**FINDINGS OF FACT
FLORENCE PLANNING COMMISSION
EXHIBIT A**

Meeting Date: June 13, 2023

Application: PC 22 21 PUD 01, PC 22 23 SUB SUB 02, & SR 22 48 SIR 13 – Myrtle Glenn

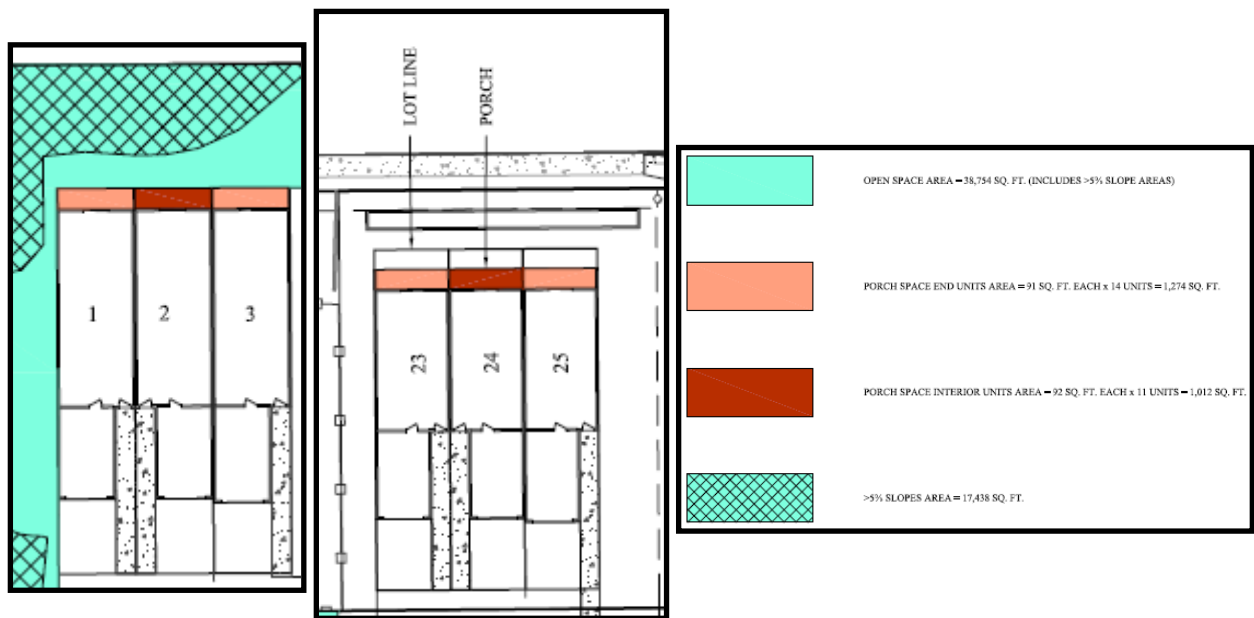
However the unattached side of the end dwelling units is proposed to be built property line tight with 0 feet of setback on the individual lot. There is 10 feet of proposed openspace held in common ownership between unattached sides if the buildings, but this does not meet the setback requirements as it is not included in the individual lot. The individual lots with unattached sides shall be adjusted in size to accommodate the 5 foot minimum setback reserved as an access easment for emergency response personnel or utility crews or the applicant’s proposal shall be reviewed as a modification to minimum side yard setbacks under FCC 10-23 (**Condition**). The applicant has already requested a modification to reduce minimum lot width under FCC 11-7, the application has the opprotunity to also request a modification to require side yard set back under FCC 10-23. This increased lot width would apply to lots 1, 3, 4, 7, 8, 11, 12, 14, 15, 18, 19, 22, 23, and 25.

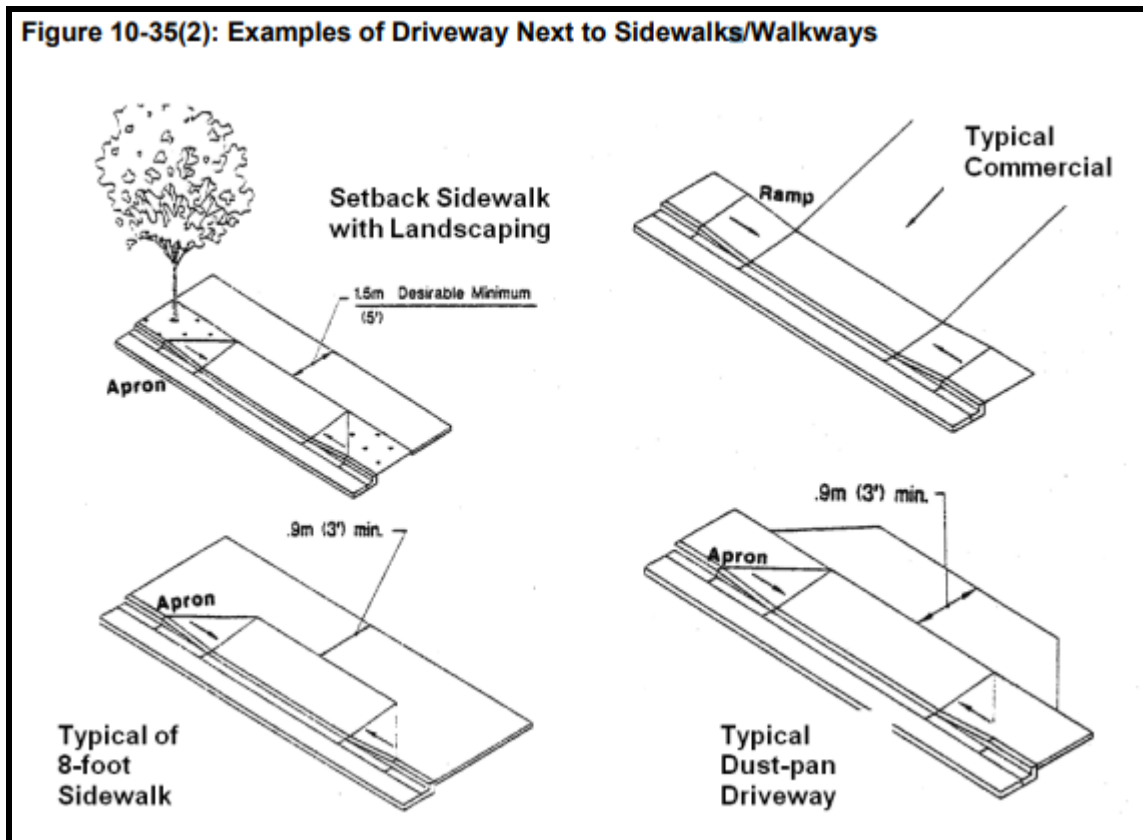
The driveway access points from 37th St into the shared parking area is proposed at 30 feet in width which exceed the maximum allowed 24 feet in width allowed under this code section. The applicant has not requested a modification for this variation in driveway width. Therefore, the maximum width shall be 24 feet and the minimum width shall be 18 feet to allow for two-way traffic circulation proposed by the applicant (**Condition**).

The grade of the drive way access was not included on the Tentative Access and Parking Plan Sheet 3 of Attachment 1 (**Exhibit C1**). However, the only significant slopes on the site are on the vegetated hill on the western portion of the property. It is not anticipated that the drive way grade will reach or exceed the maximum 15% grade. These code criteria are either met or are conditioned to be met.

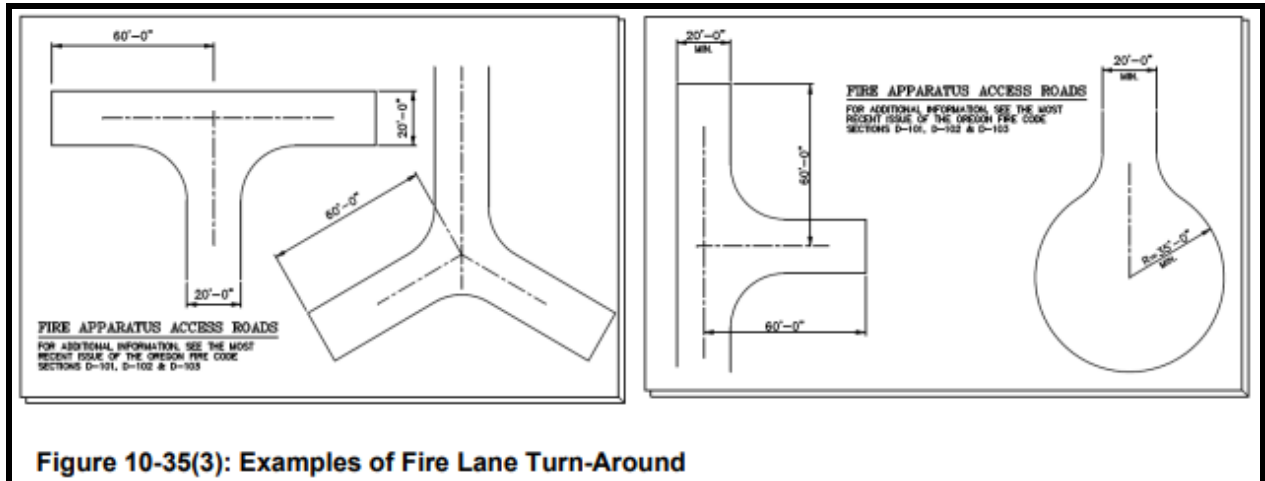
The applicant had proposed a fire access turn around location on the south west portion of 37th St approximately 70 feet from the west driveway access point (please see image below) on Sheet 3, Attachment 1 (Exhibit C1). The dimensions of the proposed turn around meet fire codes and SVFR Fire Chief reported in his referral comments that this meet fire code requirements.

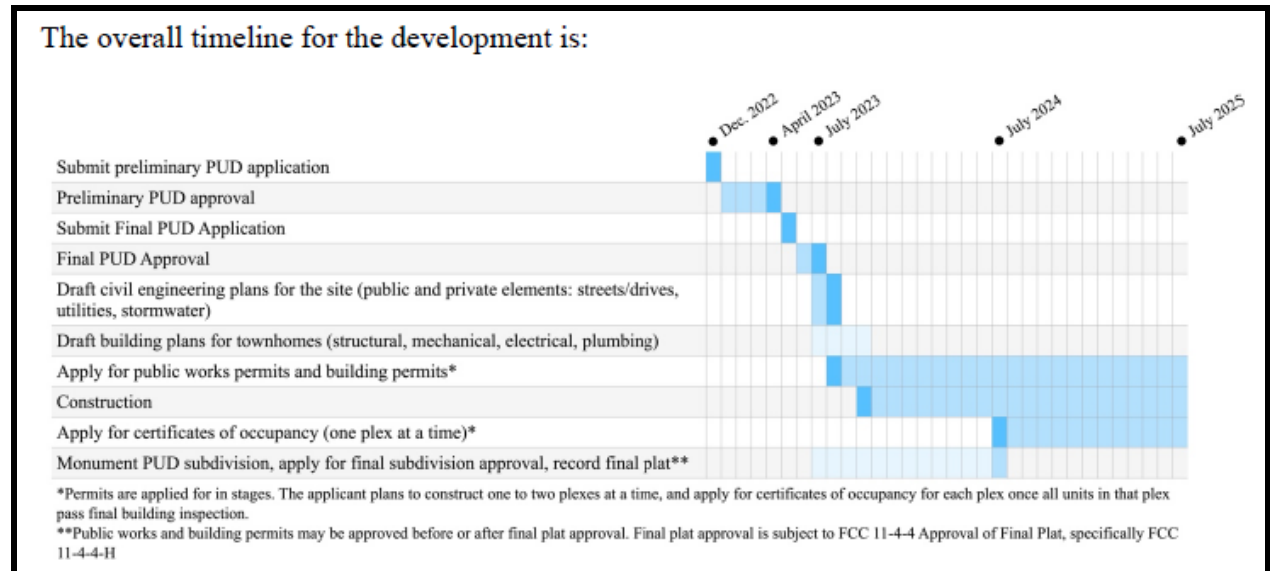
Flood control and easements for drainage facilities were included on Sheet 4 of Attachment 1 **(Exhibit C1)**. Public Work Director and Civil West Engineer comments are included in **Exhibit M**

Public Works Comments on these plans were that the Stormwater report should be approved, and the private stormwater facilities will need to be approved and inspected as each lot is built out. The referral comments state that beyond stormwater no other public utility plans were seen. Public Works Director provided comments as seen on Exhibit M.
